**RE: Town of Timmons ville Water Distribution System Improvements
Contract 1
Bid Number 04-17/18
URS Project No. 60487474**

ADDENDUM NO. 1 – August 29, 2017

FLEXIBLE PAVEMENT DRIVEWAYS

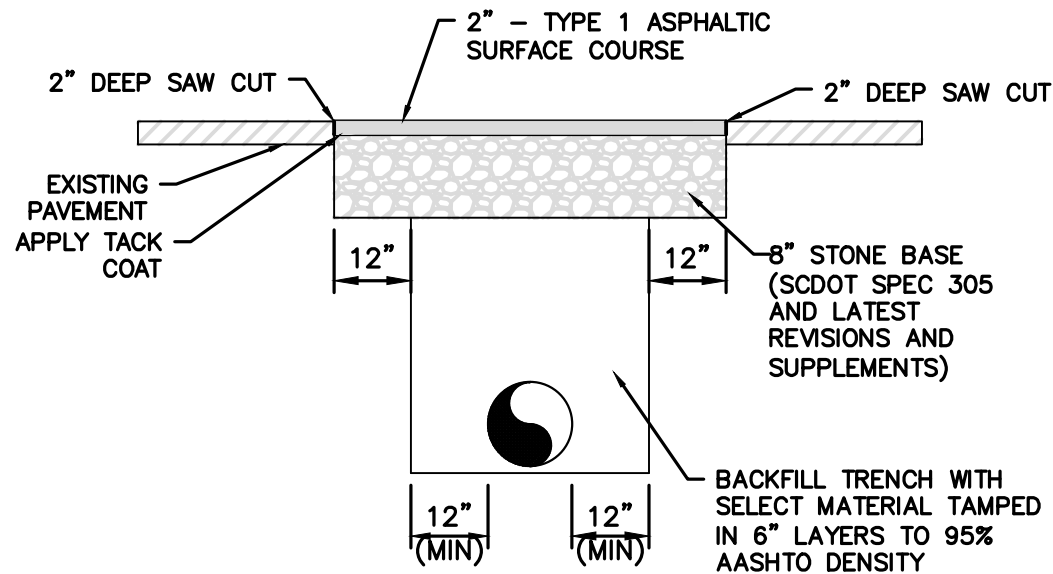
2. DETAIL 7 - SHEET 12

- A. Replace Detail 7 - Pavement Replacement & Resurfacing with Detail 7 - Flexible Pavement Driveways in Exhibit B.
